Providence City Plan Commission

AGENDA ITEM 4 ■ 1107 WESTMINSTER STREET

OVERVIEW

Building elevations

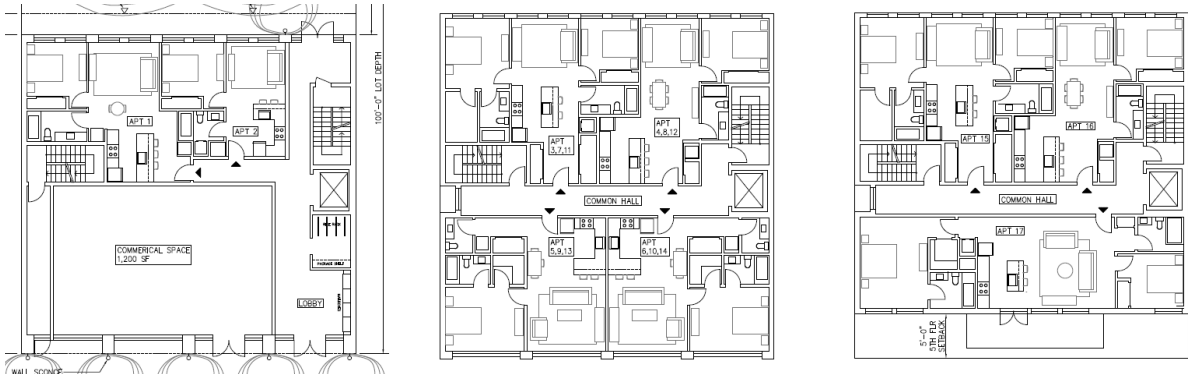
The façade will be treated with modular brick and aluminum panels with over 50% of transparency provided on the ground floor and 25% on the upper stories. Three dimensional variety is provided by setting the first and fifth stories

back from the front lot line and cantilevering the rear of the building over the parking area.

The building's design conforms to the guidelines for multifamily development in section 1202.K of the ordinance as it employs consistent materials and provides dimensional variety.

Ground floor building entrances are limited to a width of six feet and a depth of eight feet. The applicant is seeking a design waiver for the 12'10" width of the residential space from Westminster Street. The DPD makes positive findings with the criteria in section 1005.E of the Development Review Regulations (DRR):

Based on plans provided, the width of the entrance appears to be a design decision for the residential entrance, which could allow for larger articles to be moved into the building.

The CPC should vote to grant the design waiver for the proposed width of the building entrance finding that it would be in the interest of good planning practice and design.
